Reply Testimony of Kurt Mizee

PCN-2

Kurt Mizee
Exhibits 201 & 202
PCN-2 Reply Testimony

Exhibit 202

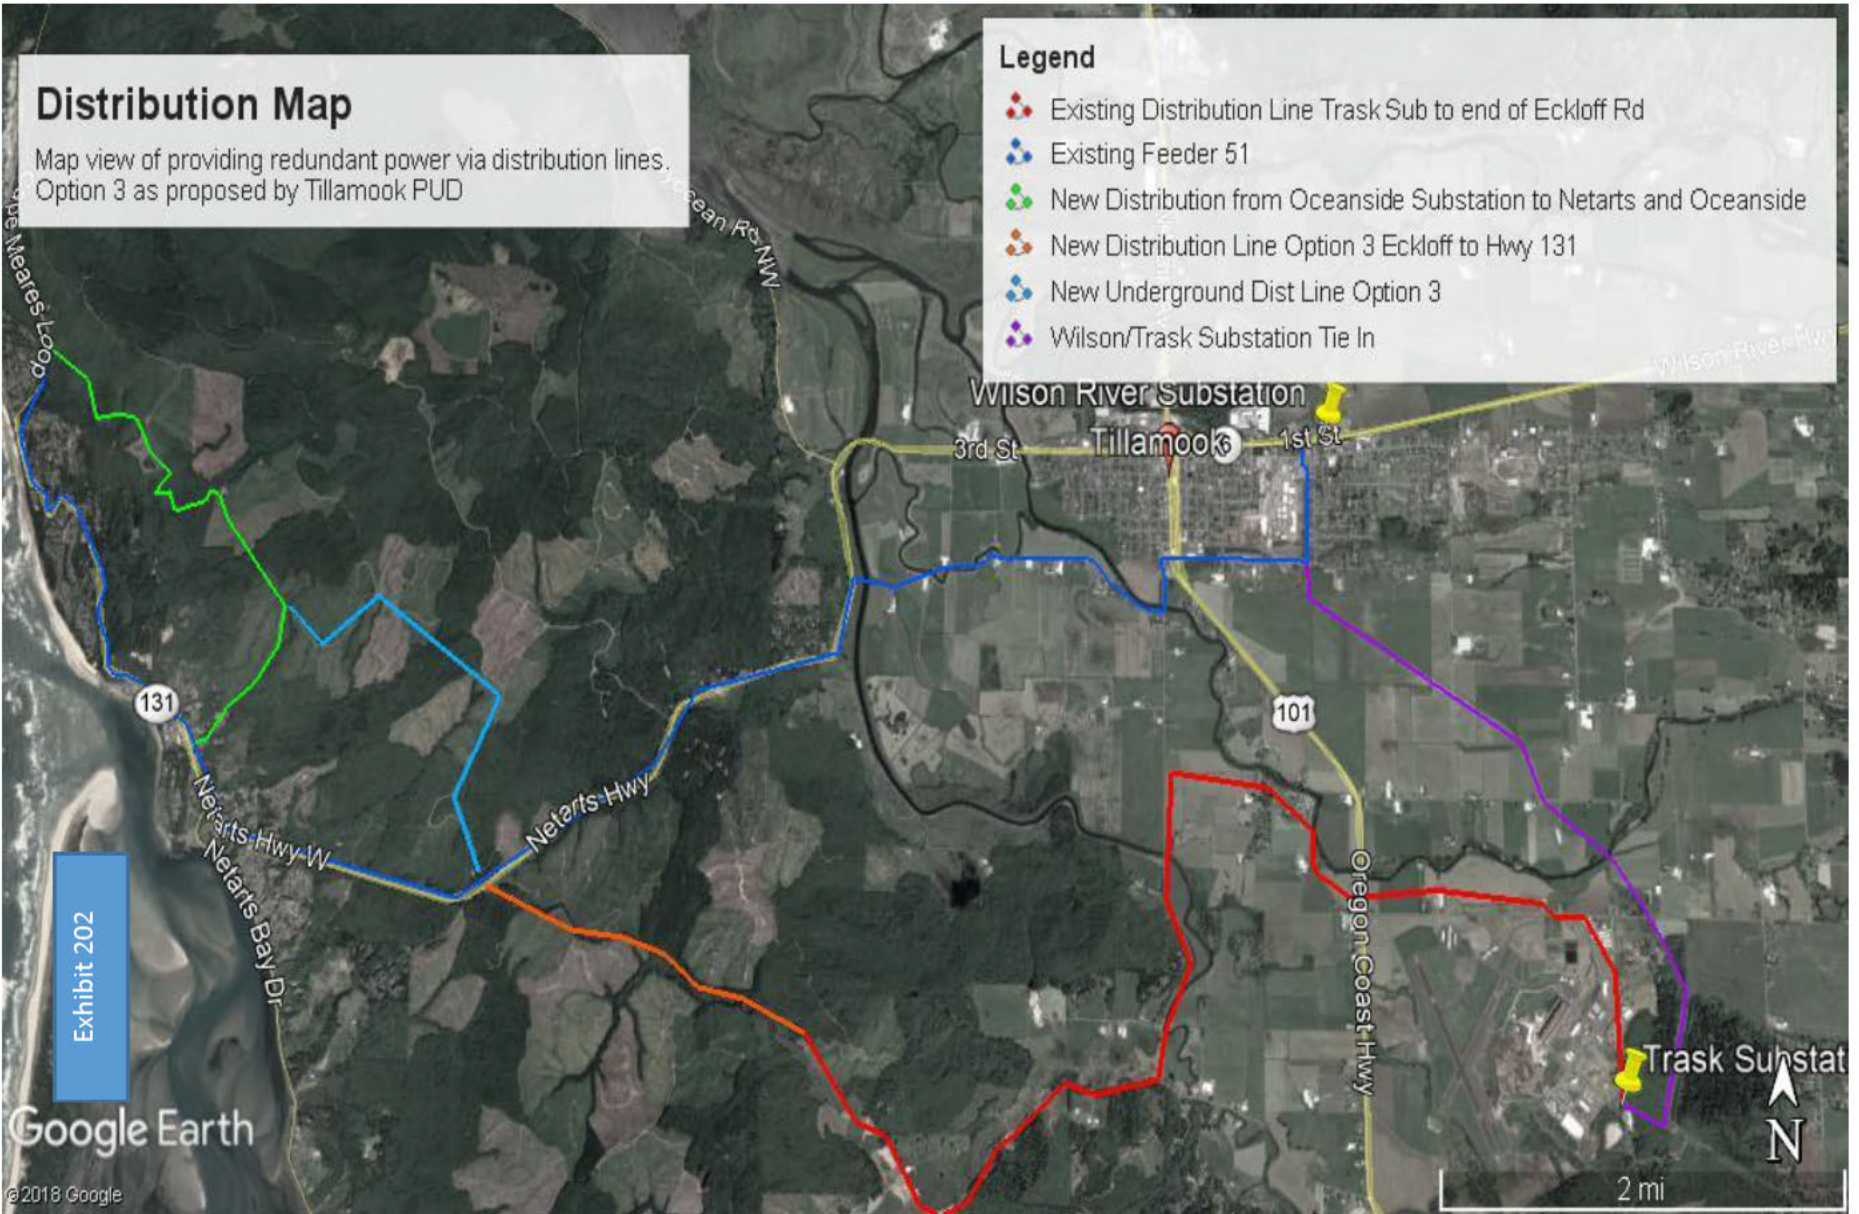
We have already noted that the public has not vetted alternative distribution routes. The maps provided and specifically Mizee 202 show that while a rebuilt Feeder 51 is capable of carrying enough load with room for growth, Option 3 adds the goal PUD has of redundancy. The red line of Option 3 is an existing distribution route along county roads. Where it turns to orange is the start of extending that line by following Eckloff road the rest of the way out to Hwy 131. At Highway 131 it crosses and they is proposed by PUD to be buried along existing logging roads to be distributed to Oceanside and Netarts. This alternative does have landowner support and does not create new impacts to any farmland while also bolstering existing distribution infrastructure.
